# Access Compliance Report

## Public Rights-of-Way

### (Pedestrian Signals)

Intersection ID: N/A	Main Street:	Cross Street: N/A	Location: N/A
ADA ID: 52057C87FEE3	Signal Type: One Push Button-Non APS	Overall Compliance: No	Severity Score: BTN 1: N/A BTN 2: N/A No BTN: N/A
Codes/Mitigation Info/Possible Solution		Field Measurements/Component Compliance

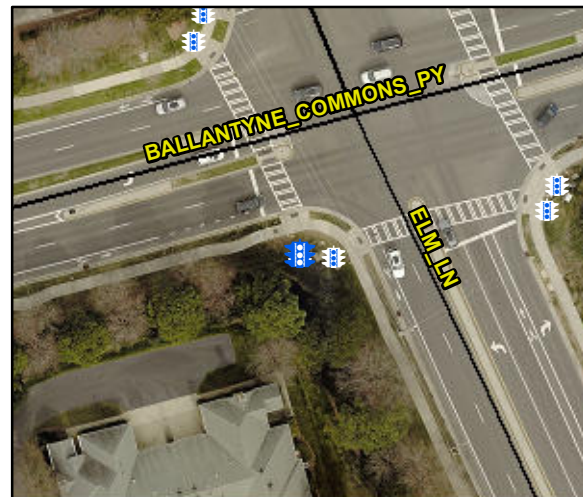
PROW/ADA: TMUTCD 4e.08

Yes	B 1 Clear Xing Direction?	ClearlyMarked	N/A	B 2 Clear Xing Direction?	N/A
	B 1 Crossing Direction	To NW		B 2 Crossing Direction	N/A
Yes	B 1 DistanceTo XWalk (in)	31.0	N/A	B 2 DistanceTo XWalk (in)	N/A
No	B 1 DistanceTo Curb (in)	157.0	N/A	B 2 DistanceTo Curb (in)	N/A
Yes	B 1 Diameter (in)	2.0	N/A	B 2 Diameter (in)	N/A

Possible Solutions: Replace Signal Push Button With APS Button on New Post. Remove & Relocate Sign.
